780 BLANSHARD - REHABILITATION + ADDITION

HAV00034 CONCURRENT WITH REZ00825 - RESUBMISSION 03

780 Blanshard - Rehabilitation + Addition

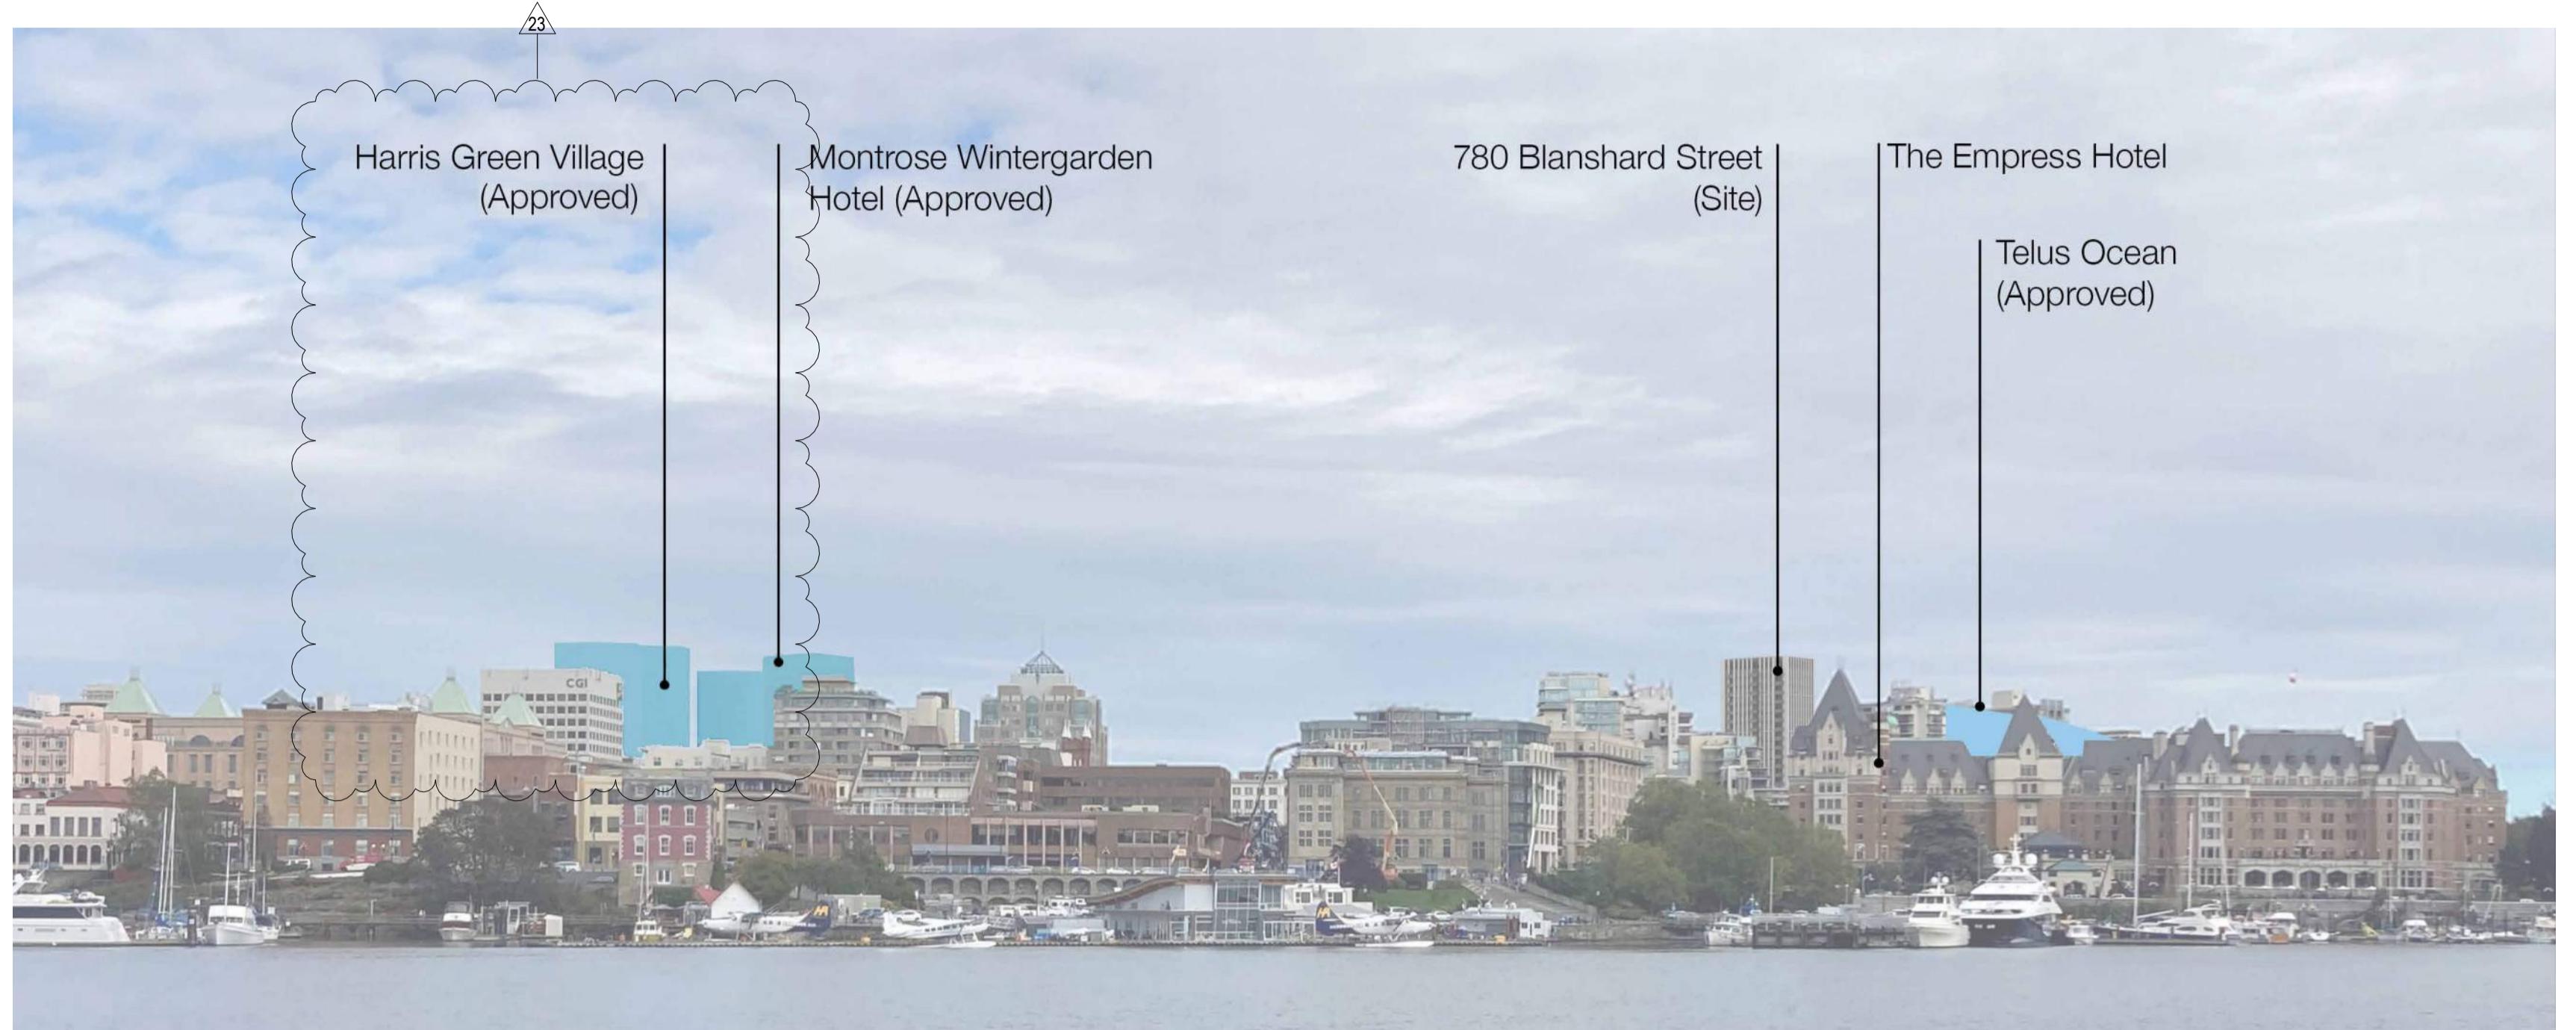
- 1 Per plan check comment #5.1, area calculation revised to include mechanical and electrical spaces on Level 01 which were excluded in previous calculation. Corresponding note for Column C deleted. Prorated floor area allocation and overall FSR adjusted to suit.
- 2 Residential long-term bicycle parking revised on Level 01 to change basis of design for stacked bicycle racks to address plan check

basic of design for stacked bicycle racks to address plan check comment #5.6. Parking space counts updated to reflect revised bike room plans. Dimensions have been added for clearance at walls / columns.

3 To address plan check comment #5.5, the short-term bicycle parking spaces previously shown on Burdett Avenue ROW have been removed and short-term stalls partly locate on Fairfield ROW have been relocated fully on subject site.

SITE PLAN PROPOSED

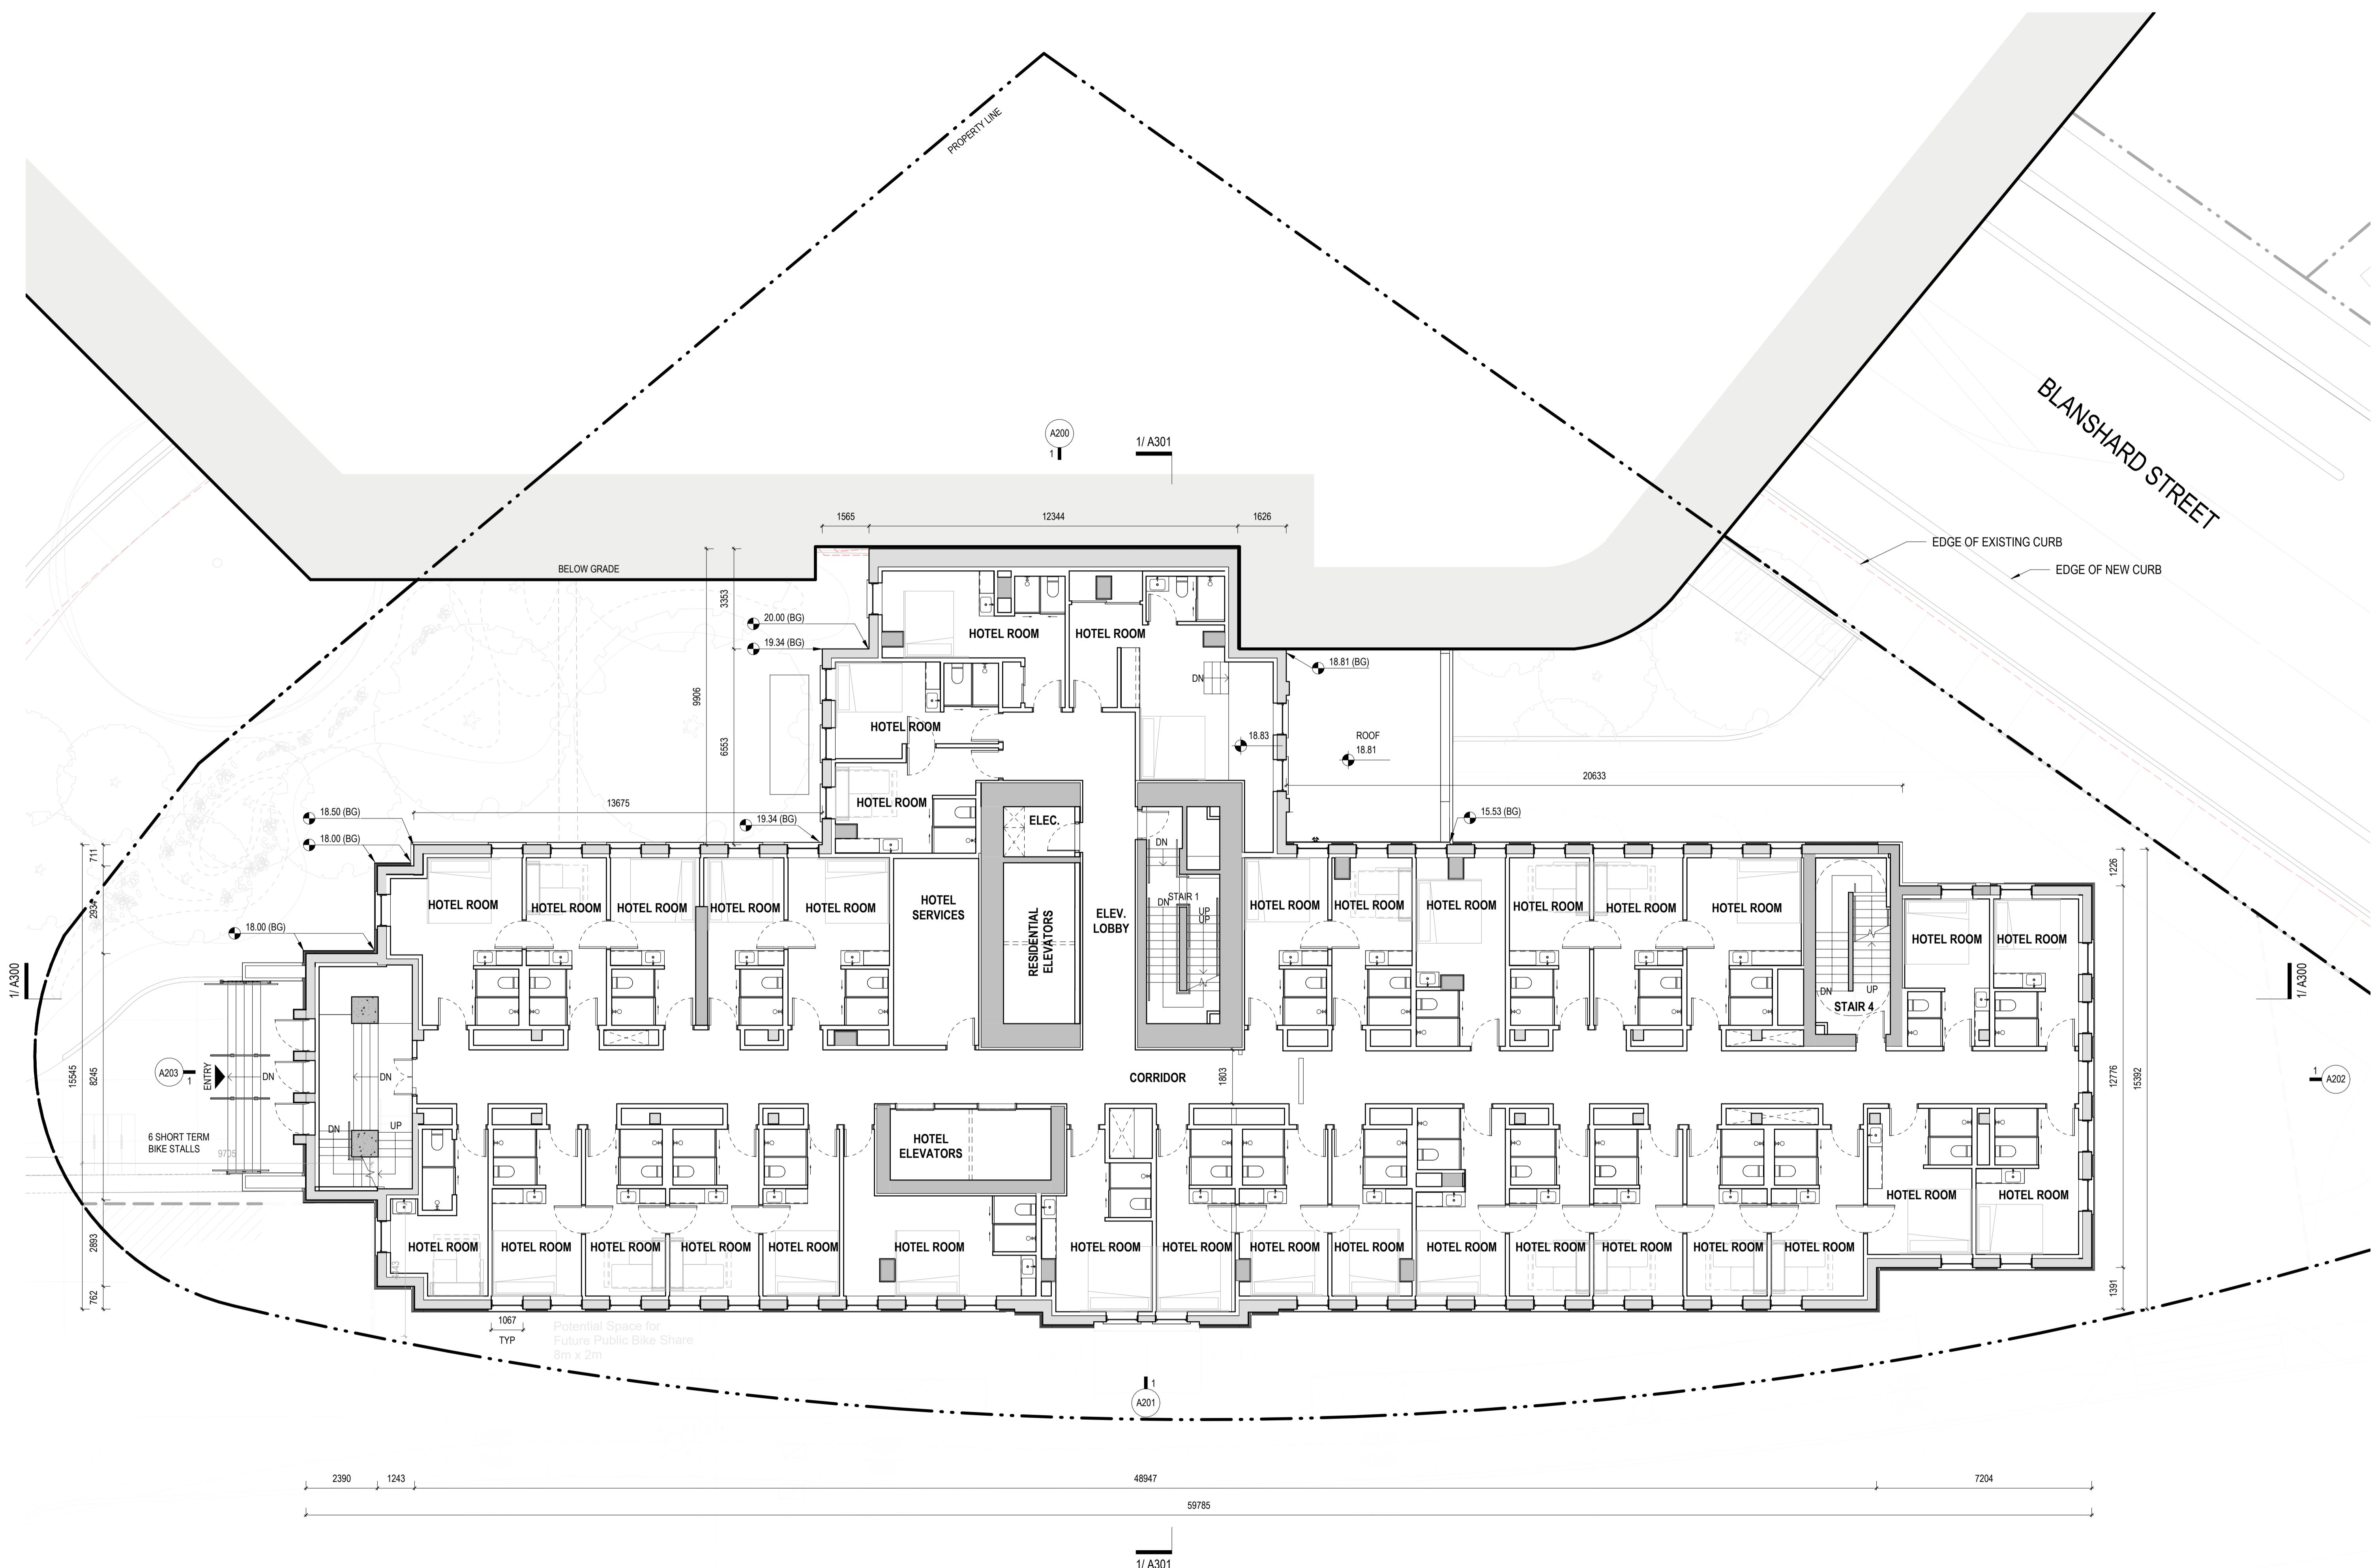
5 Burdett Avenue sidewalks reconfigured and two-way vehicle movement provided per discussions with Staff and reflected in small summary comments and concept design drawing from City of Victoria. See Civil drawings and Response Comments #4.1 and #4.2.

6 Car share parking stalls and public car charging stall moved to north side of Burdett Avenue to accommodate two-way vehicle movements and locations for south side curb due to PR2 of existing trees. See further discussions and redesigned street in Response Comments #1.39, #4.2, #4.6, and #4.15.

7 Short-term curb-side parking stall removed to accommodate two-way design of Burdett Avenue per City comment and concept drawing. See Response Comment #4.5.

8 Proposed short-term bicycle parking on City ROW removed per City comment. See Response Comment #4.5.

9 Short-term bicycle parking spaces removed from ROW to address City comment. See Response Comment #5.5.

10 Proposed curb-side stall for short-term loading, delivery, and pick-up/drop-off use. Used as proposed as a result of loss of short-term stall on Burdett Avenue due to redesign for two-way vehicle movement per City request. See further discussion in Response Comments #4.1 and #4.12.

11 New street trees in grates coordinated with transit layby. See also Landscape drawing L1.0, Civil drawing C03, and Comment Responses #1.6, #1.23, #12.2, #1.31, and #4.14.

12 Large street tree within SRW per City comment. See Comment Response #4.9.

13 Blanshard Street cross section redesigned per City comments and concept drawing. See also Civil Drawing C03 and Response Comments #4.5.

14 Blanshard Street cross section redesigned per City comments and concept drawing. See also Civil Drawing C03 and Response Comments #4.5.

15 In response to City comment, a mountable curb is proposed for the whole south Burdett street edge. See Civil drawing C03 and Response Comment #4.5.

16 Driveway-style crossings provided at Burdett Avenue intersections per City comment. See Response Comments #1.3 and #4.3.

17 SRW along existing retaining wall proposed per City comment. See Response Comments #3.2 and #4.3.

18 New street lighting. See also Electrical, Civil, Landscape drawings and Response Comments #1.5 and #4.16.

19 Proposed SRW for sidewalk clearance around street trees at front of building. See Civil drawing C04 and Response Comment #1.4.

20 Proposed SRW at intersection. See also Civil drawing C04 and Response Comment #1.4.

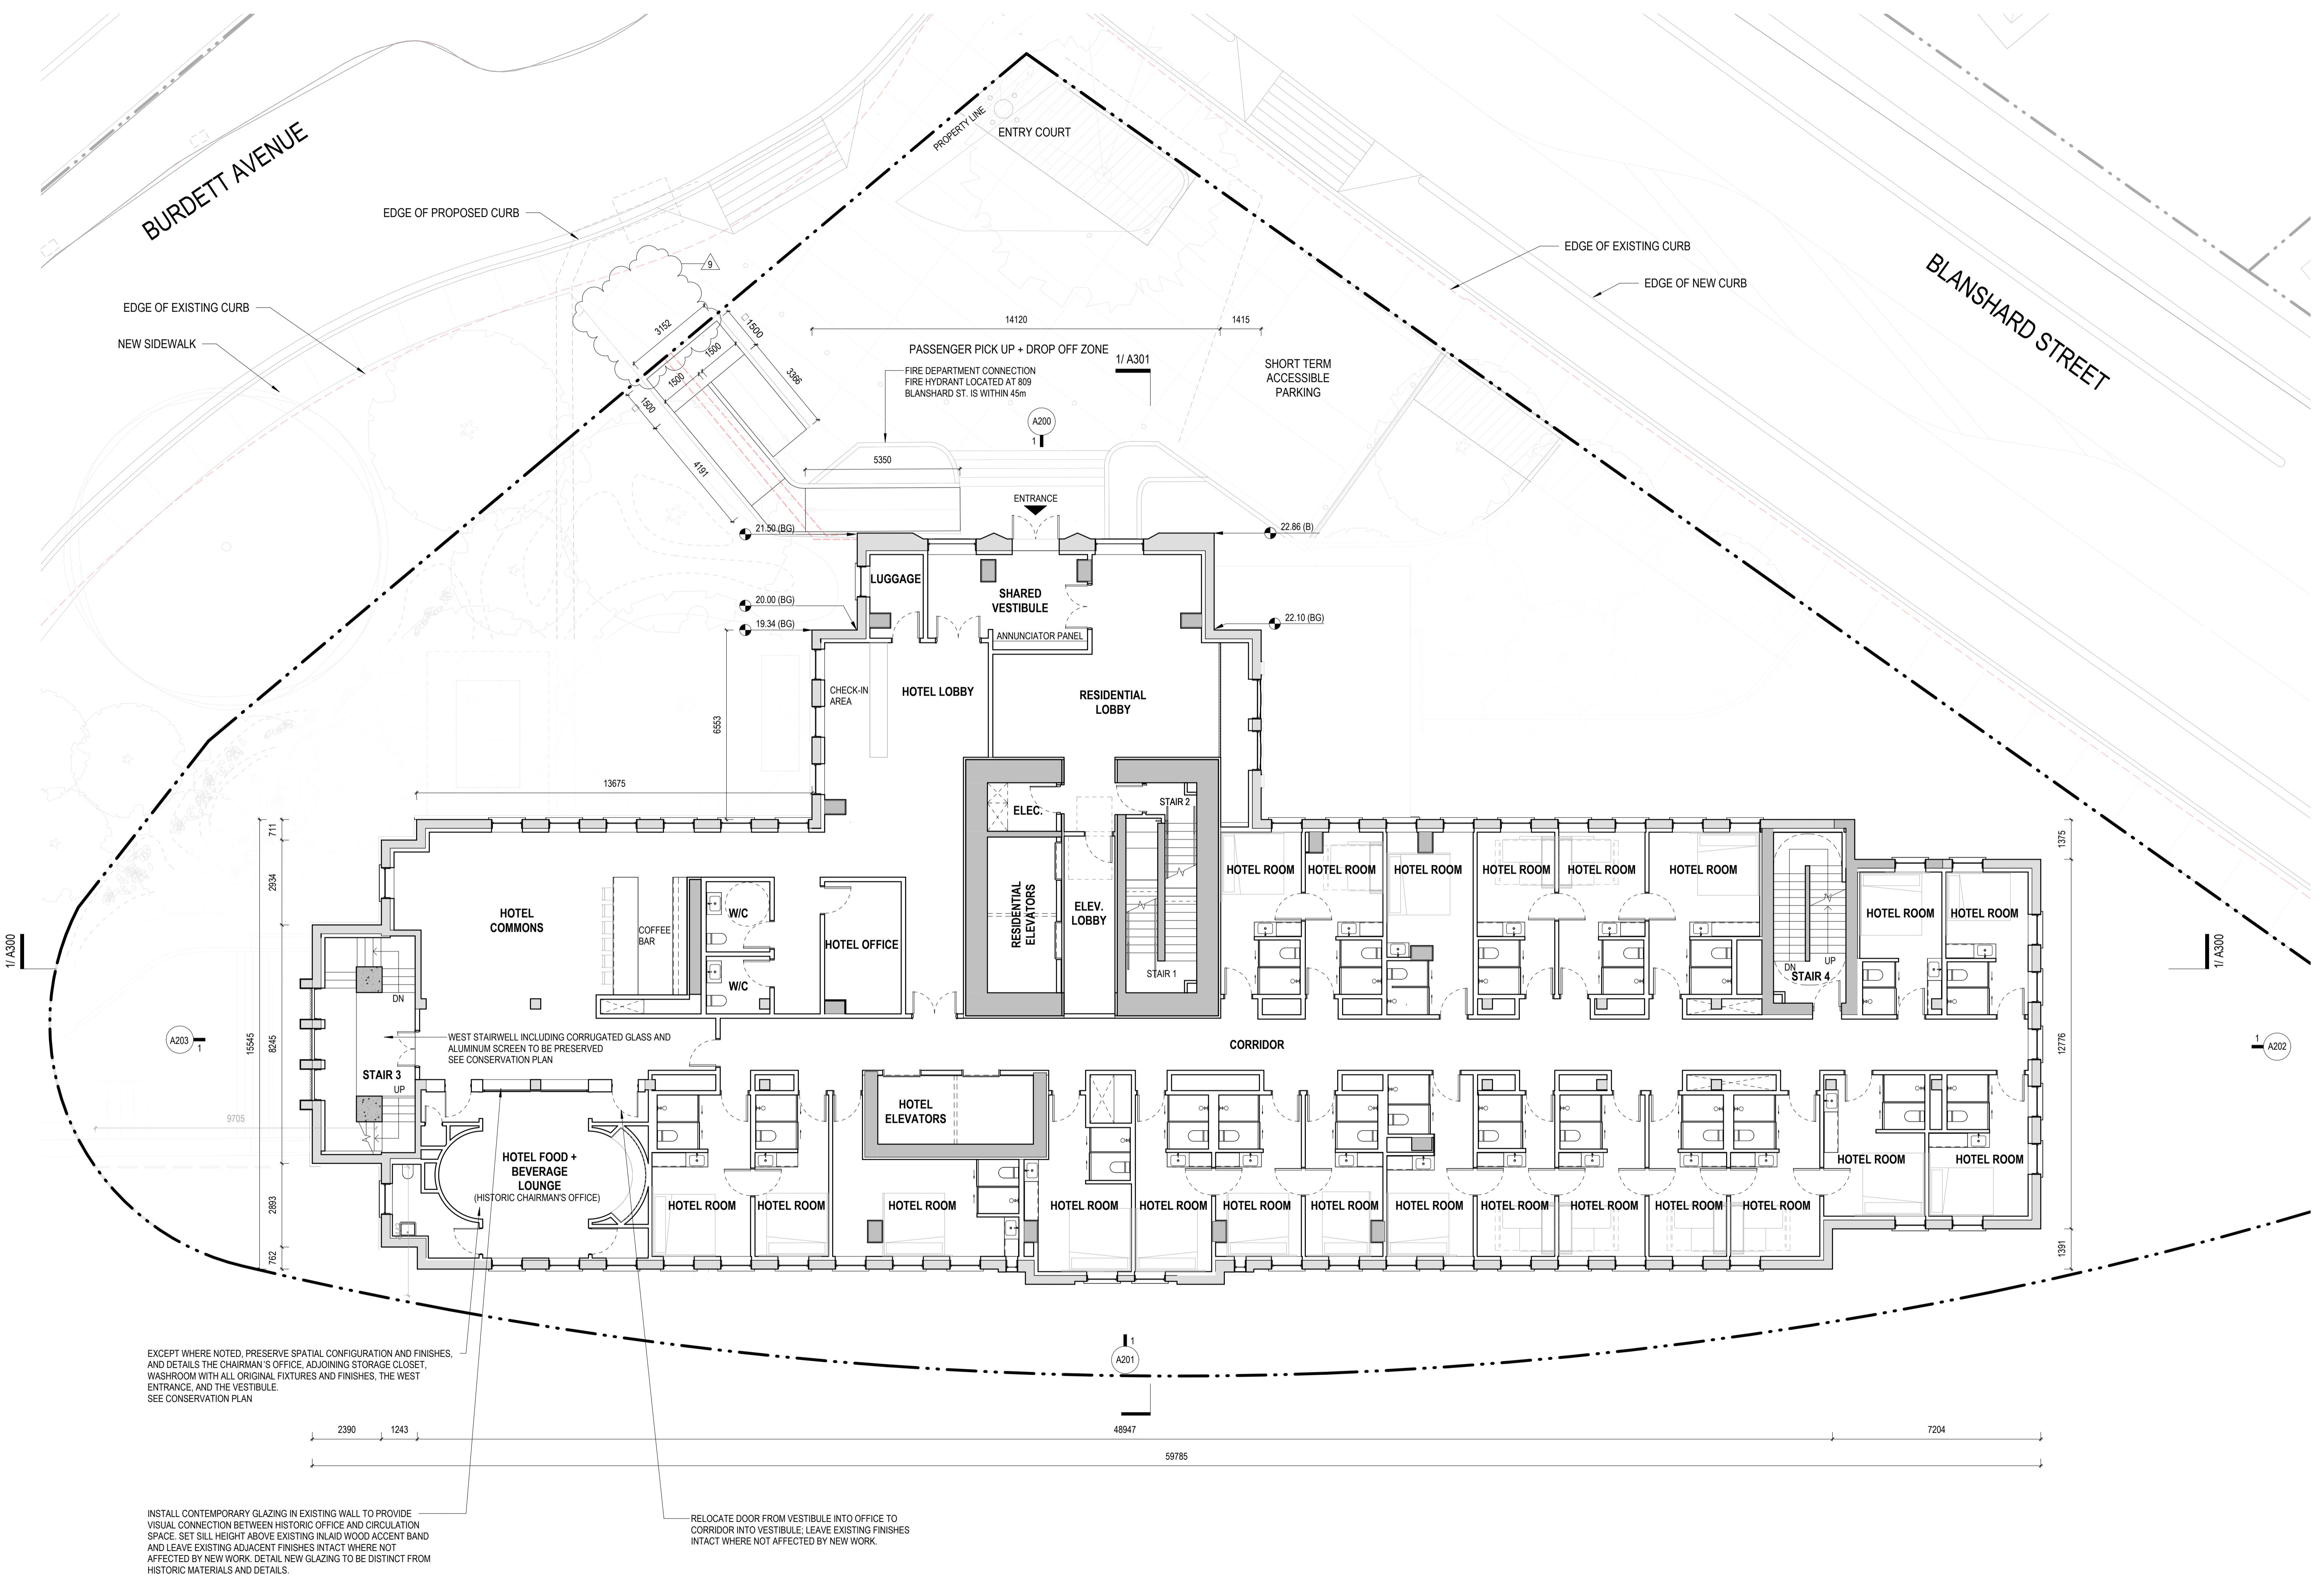
hort-term bicycle parking spaces removed from ROW to address comment. See Response Comment #5.5.
